Report to the Future Melbourne (Planning) Committee

Melbourne Metro Rail Project – City of Melbourne’s submission to the Environmental Effects Statement

5 July 2016

Figure 1 – Fawkner Park TBM Launch Site (Melbourne Metro Rail Project EES – Map Book)

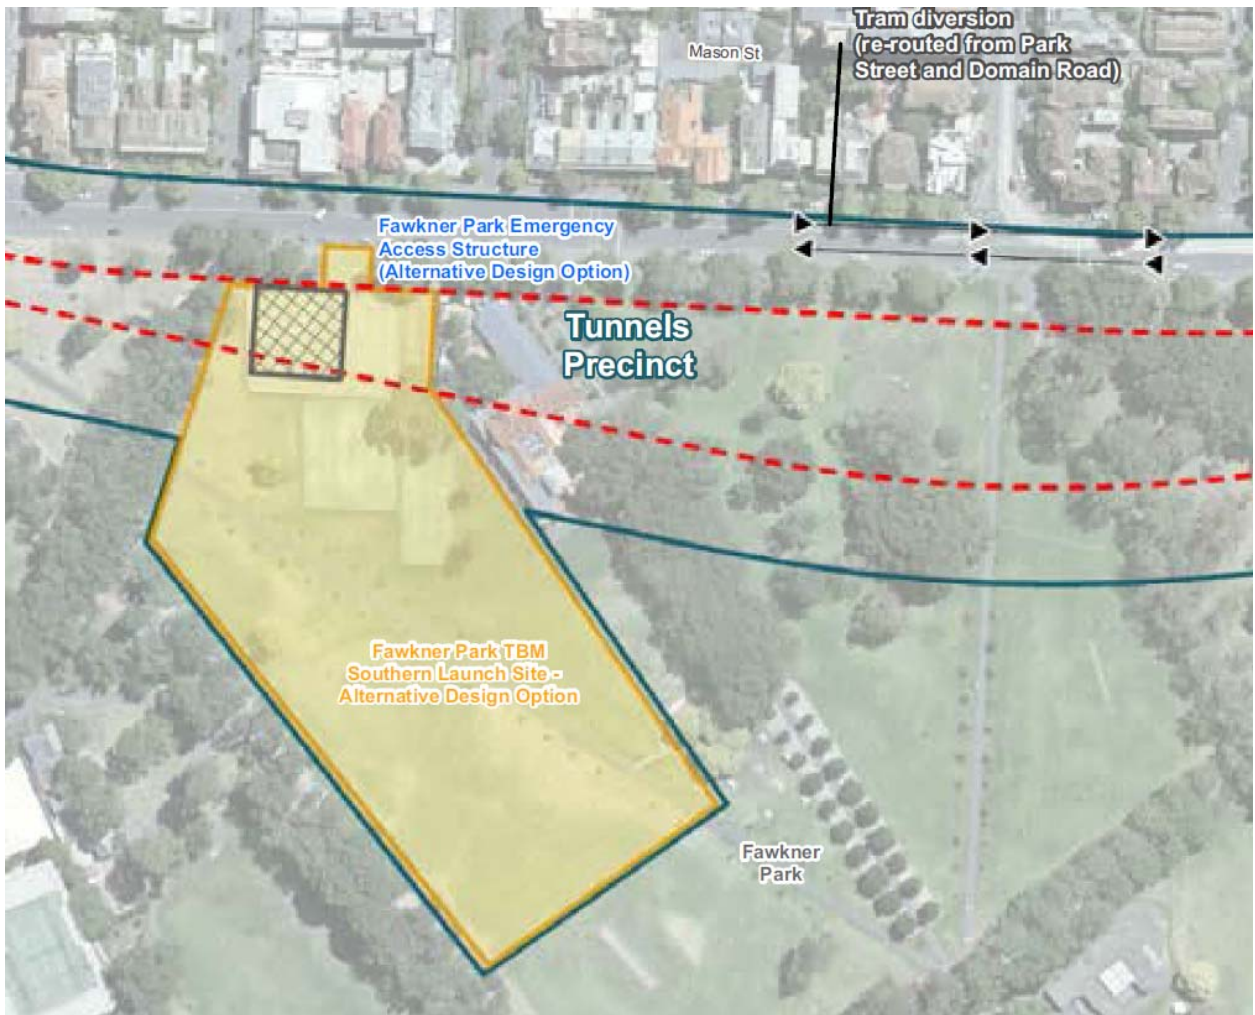
The diagram below shows the area of Fawkner Park proposed to be used for the potential TBM launch site. The next diagram shows the Domain Station Precinct including Edmond Herring Oval.

Figure 5 – Construction work near CityLink tunnel alignment (EES Map Book)

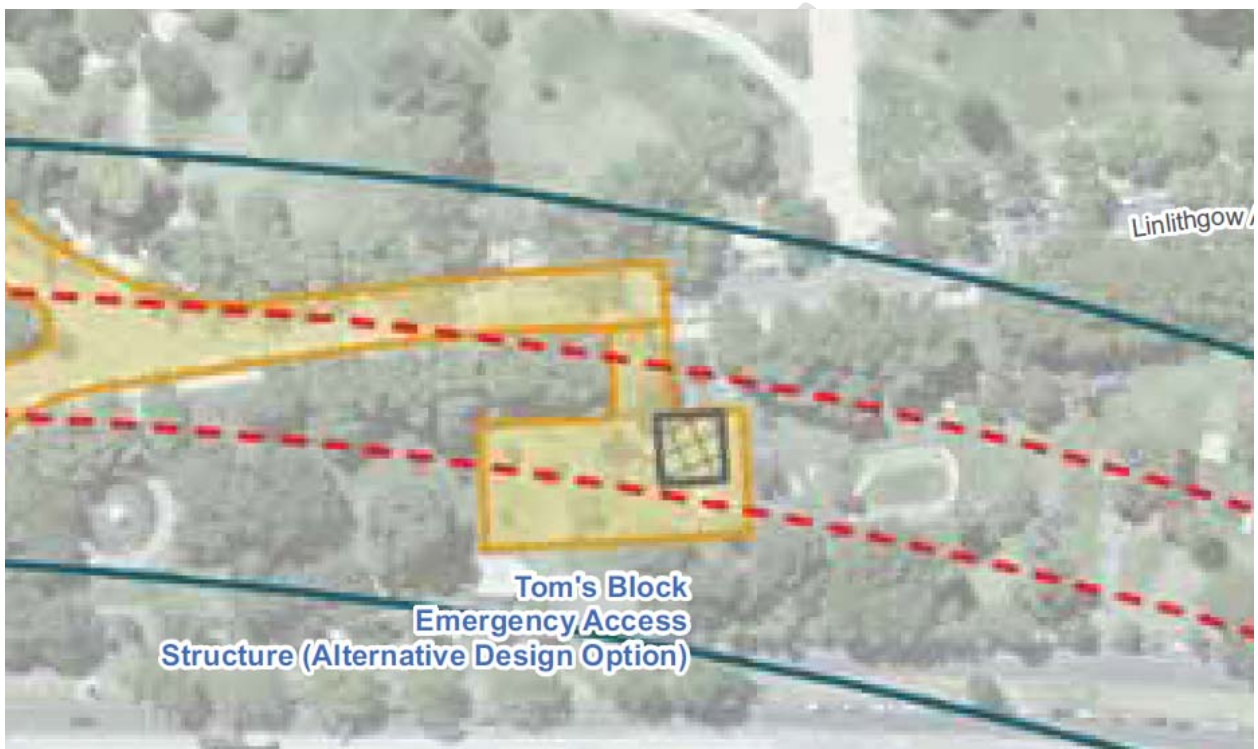
A tunnel alignment above the CityLink tunnels would have a greater impact at ground level than the lower alignment. The former would require permanent ground stabilising works in Tom's Block. The EES Map Book shows the following information regarding construction work in the vicinity of the CityLink tunnels.

Figure 7 – Area potentially requiring ground treatment at the CityLink crossing (EES Appendix P – Ground Movement and Land Stability)

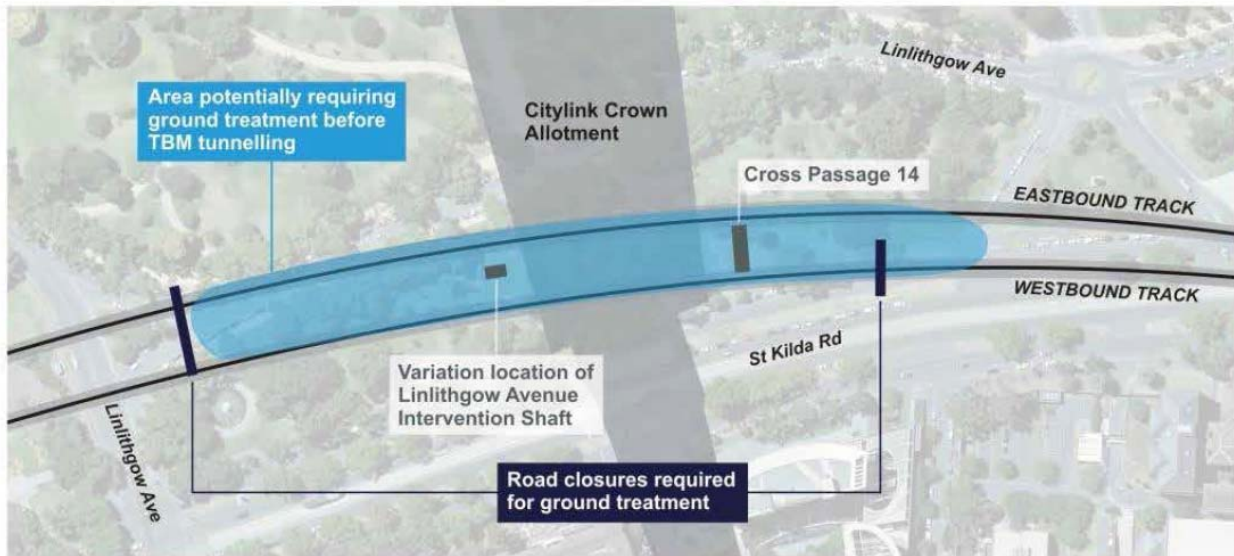
The following diagram is provided in Appendix P - Ground Movement and Land Stability (page 89) showing the area of land potentially requiring stabilisation works.

Figure 8 – Emergency Access Shaft Location (Melbourne Metro Rail Project EES – Map Book)

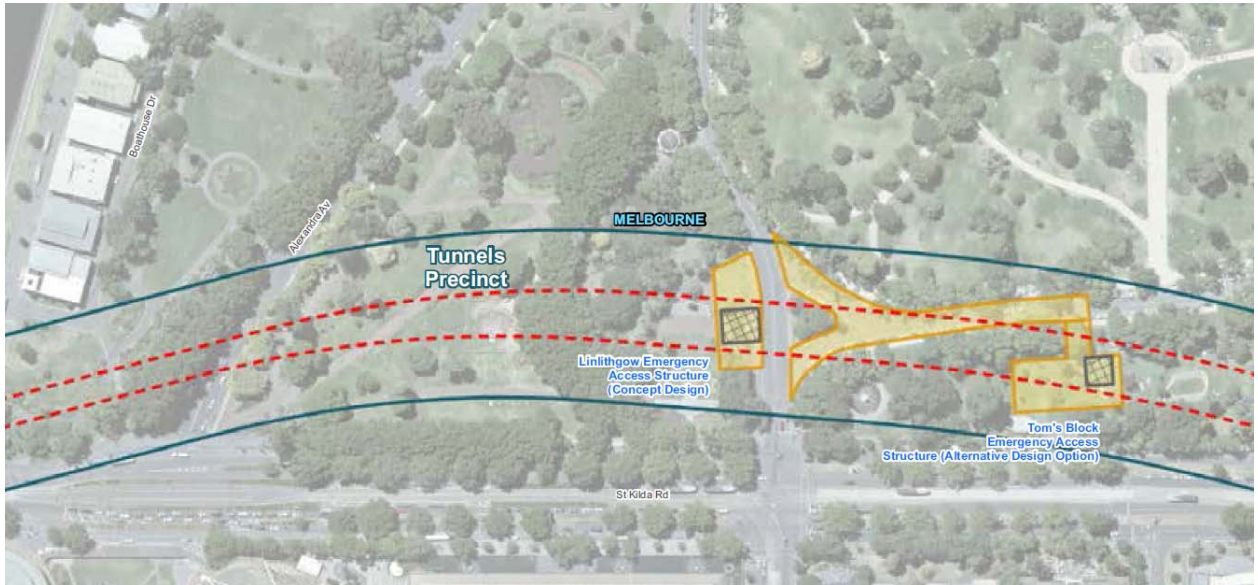
The two proposed locations for the Emergency Access Shaft considered as part of the EES are shown in the diagram below.

Figure 11 – Fawkner Park Emergency Access Shaft Locations (Melbourne Metro Rail Project EES – Map Book)

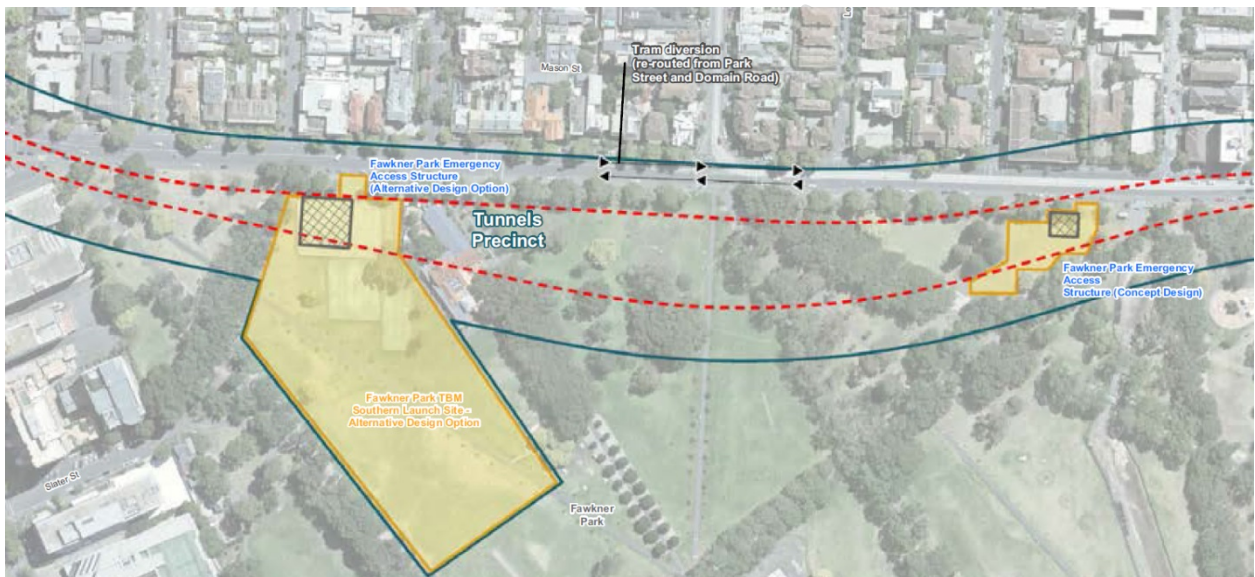
The second Emergency Access Shaft is proposed to be located between the Domain Station and Eastern Portal. This section of the tunnel alignment generally follows Toorak Road West. The two options for the shaft are both shown to be within Fawkner Park.

Figure 21 – Optional Location for electrical substation at 50 Lloyd Street (Melbourne Metro Rail Project EES – Map Book)

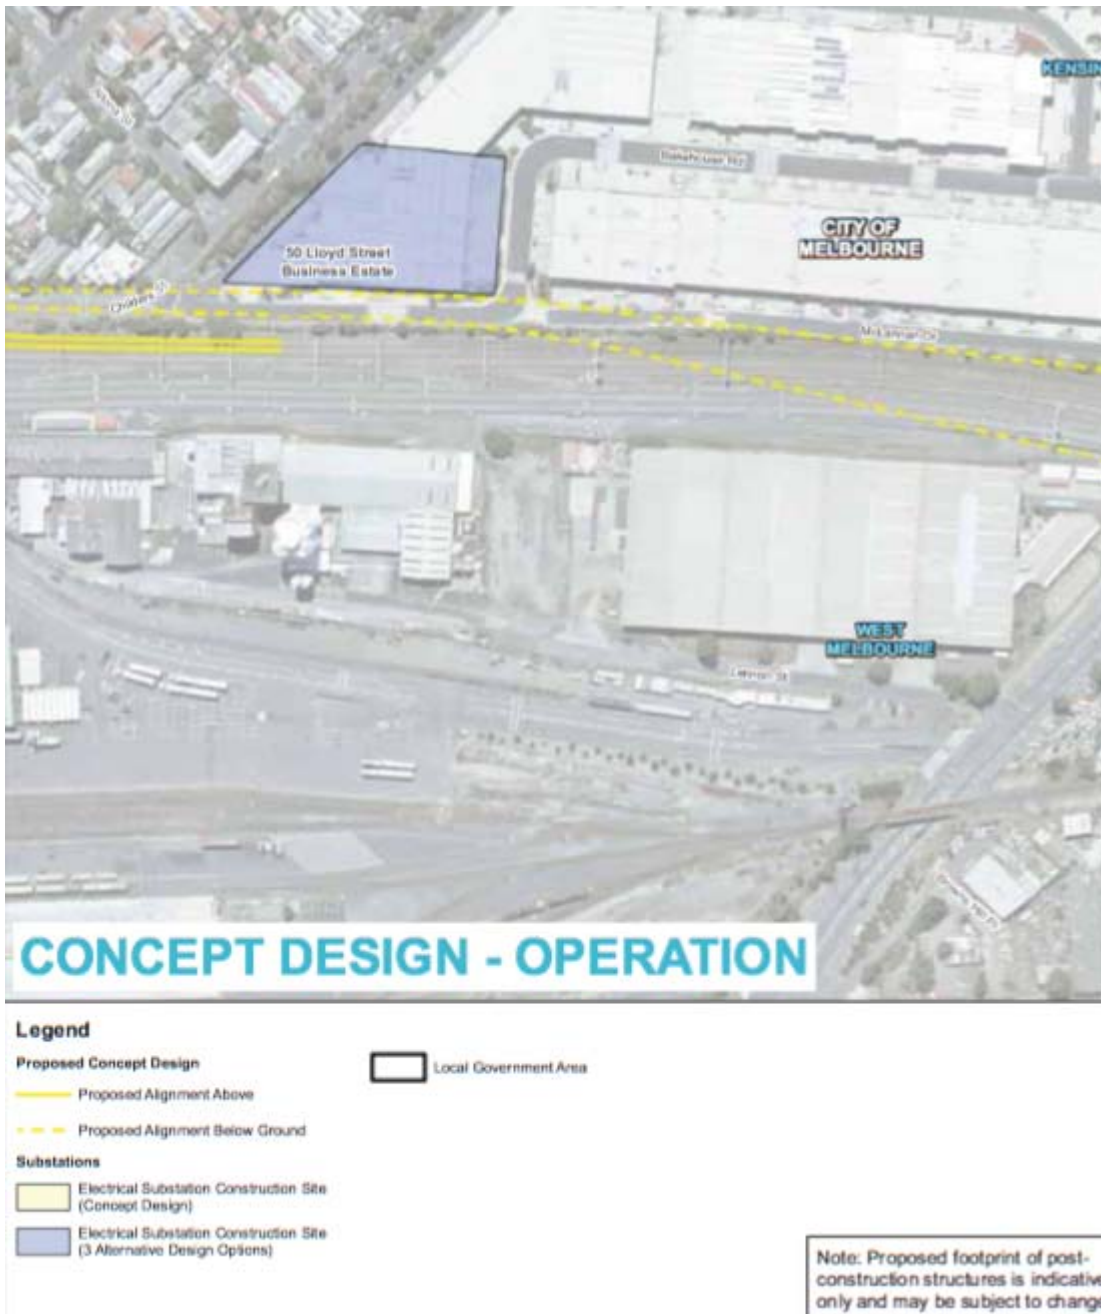
The Map Book identifies the south-west portion of the business park 50 Lloyd Street being a potential location for an electrical substation construction site (see Figure 21 below). The substation is in the currently location of 13 business park units. It is assumed that the substation would be an above ground structure. There is insufficient detail about the substation to be able to fully determine the impacts of this structure, however a location that is further from existing residential properties and does not require private property acquisition is preferred.

Figure 22 – Aerial image including Arden Siding (CoMPASS)

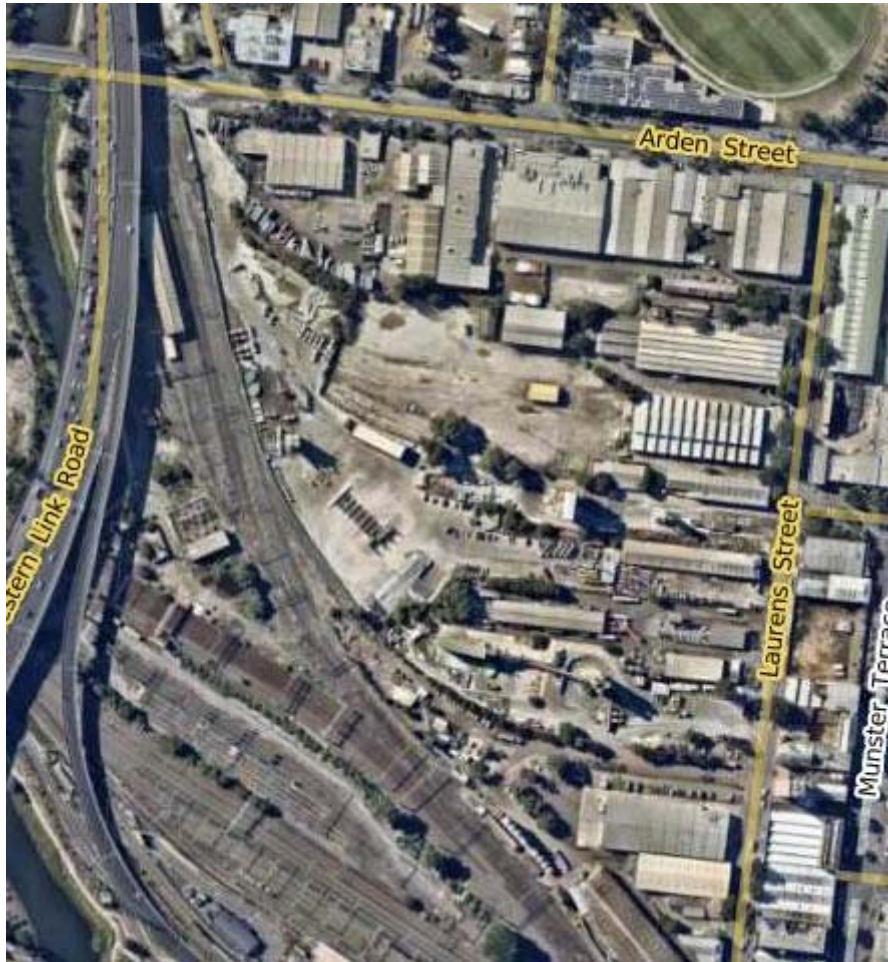
The Arden Siding site currently contains a number of trees at various states of maturity. The City of Melbourne does not have its own detailed information about trees planted on this land. The image below is an aerial image of the site where tree canopies can be seen (see Figure 22). These trees have been retained over time despite existing industrial activities being carried out on the land and substantial truck movements through the site. The Arboriculture Technical Appendix documents indicate approximately 115 trees being removed from this site. The reason for their removal is unclear. EPR AR 1 states in part:

This area is largely Vic Track land and therefore the City of Melbourne has no jurisdiction over this area. However this area has been earmarked for future urban renewal. This area will be developed in the future and it will be desirable to retain as many trees as possible to allow mature trees to be present for the future redeveloped area. It is submitted that this EPR should apply equally to trees on public and private land, such as the Arden Siding. The retention of trees on this land would contribute to the urban ecology and visual landscape of this urban renewal area.

Figure 23 – Proposed Heritage Overlay under Planning Scheme Amendment C 207 (CoPASS)

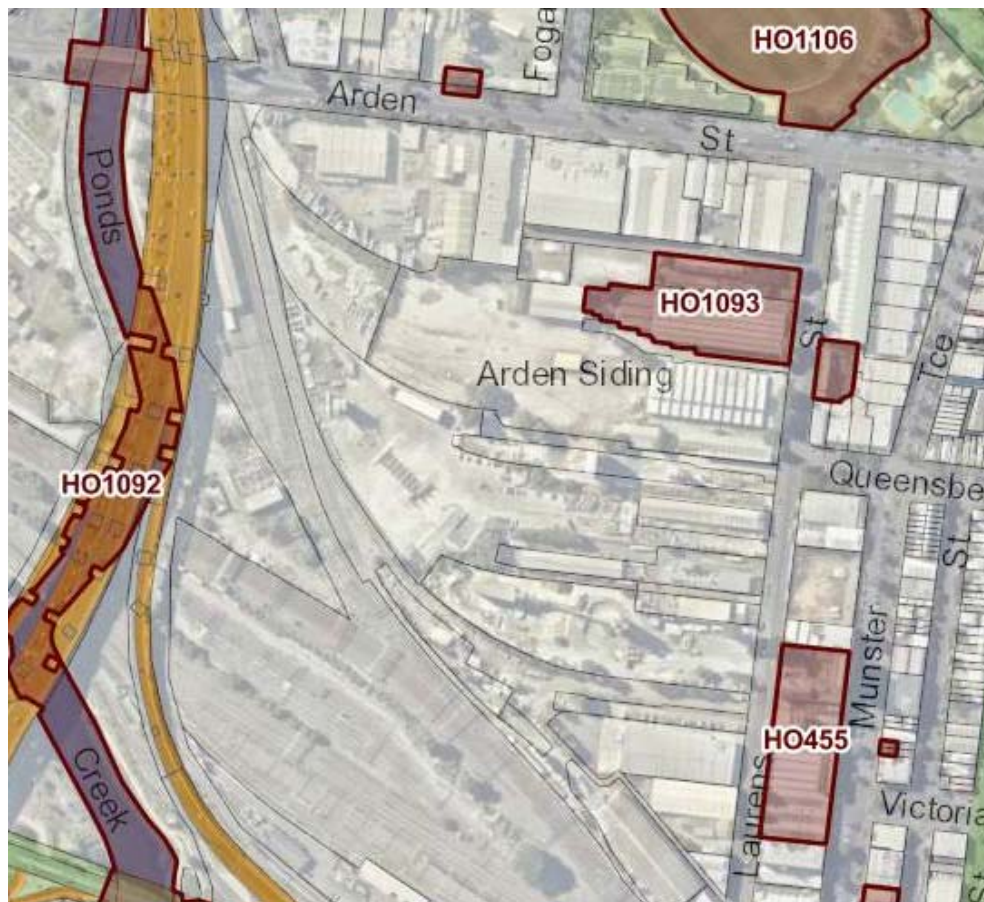
within the Arden Siding rail land. The City of Melbourne would welcome the opportunity to explore options to retain or reuse these buildings.

Figure 30 – Concept Design Construction Area for Parkville Station Precinct (Melbourne Metro Rail Project EES – Map Book)

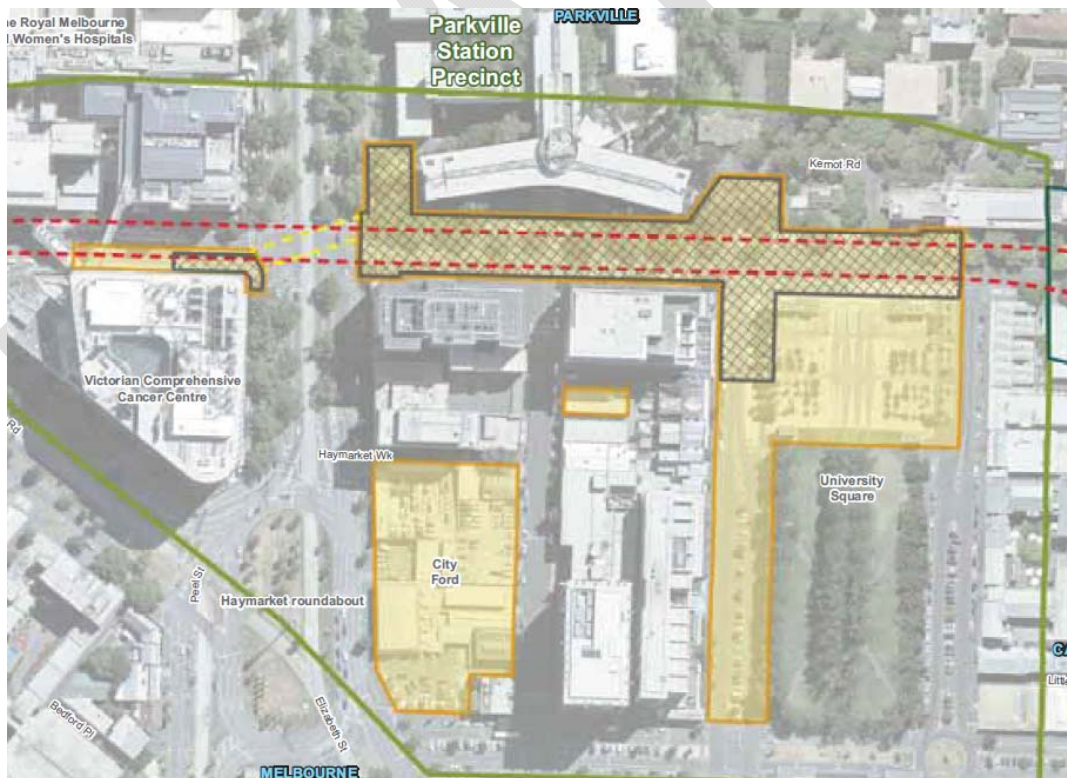
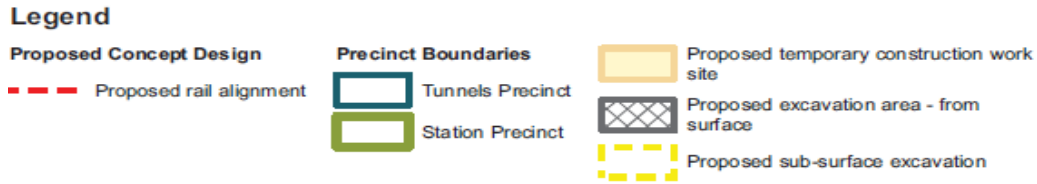
The EES describes the temporary occupation of the decked area of the northern portion of University Square to be used during construction. University is Crown land with a Crown lease for the public car park that is currently held by Melbourne University. The City of Melbourne is the Committee of Management for University Square.

The City of Melbourne supports the temporary occupation of the western portion of paved plaza in the north-west area of University Square together with temporary occupation of Barry Street. Occupation of the entire northern portion of the Square will significantly affect access (both visual and physical) between the University of Melbourne campus north of Grattan Street and facilities south of Grattan Street and is therefore not supported. University Square is completely surrounded by Melbourne University buildings.

Figure 35 – Franklin Street alternative Concept Design(City of Melbourne)

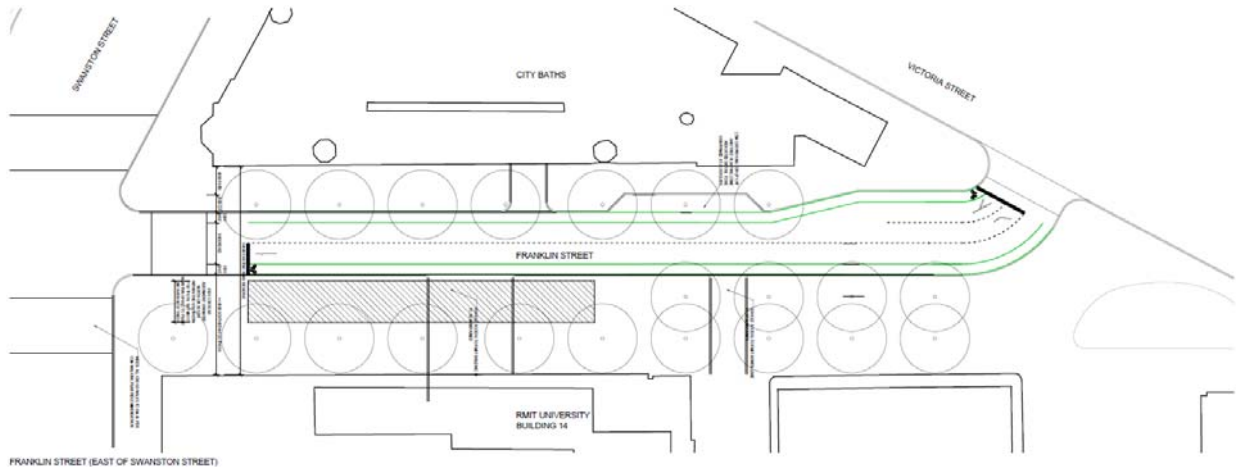
This matter has been discussed with the MMRA. It is understood that a functional layout can be achieved by moving the station entrance and other infrastructure towards the south side of the street. This would also allow for a widened footpath area with substantial tree planting and allows for the potential of this landscaped avenue treatment being continued for the length of Franklin Street to the Queen Victoria Market. By this means, an improved level of pedestrian amenity can be achieved to link a significantly upgraded QVM Precinct, as per the Master Plan, to the City North Station.

Figure 36 – Franklin Street alternative Concept Design (City of Melbourne)

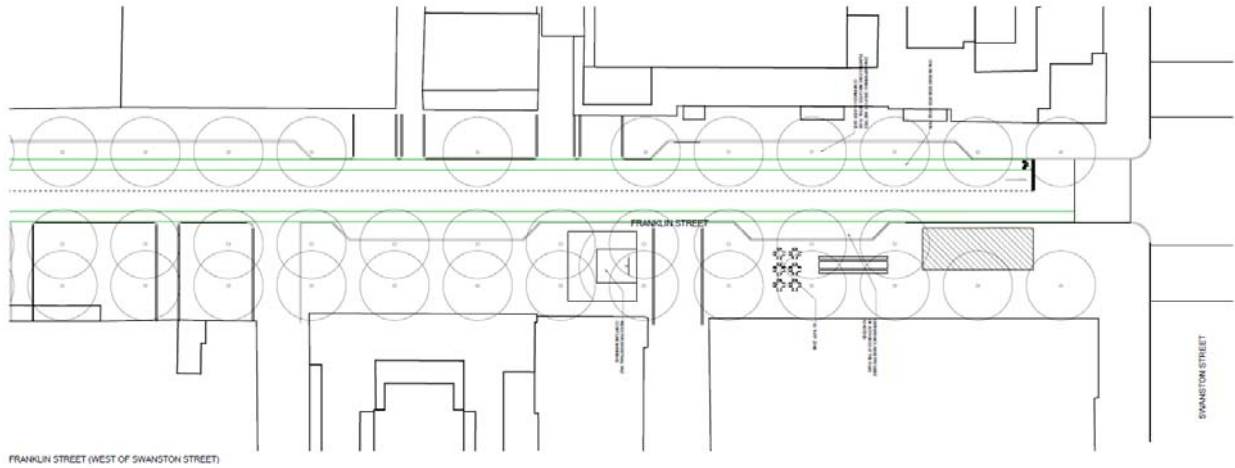
The following diagram provides an indication of how this treatment might be continued along Franklin Street on the eastern side of Swanston Street incorporating the proposed Emergency Access Structure.
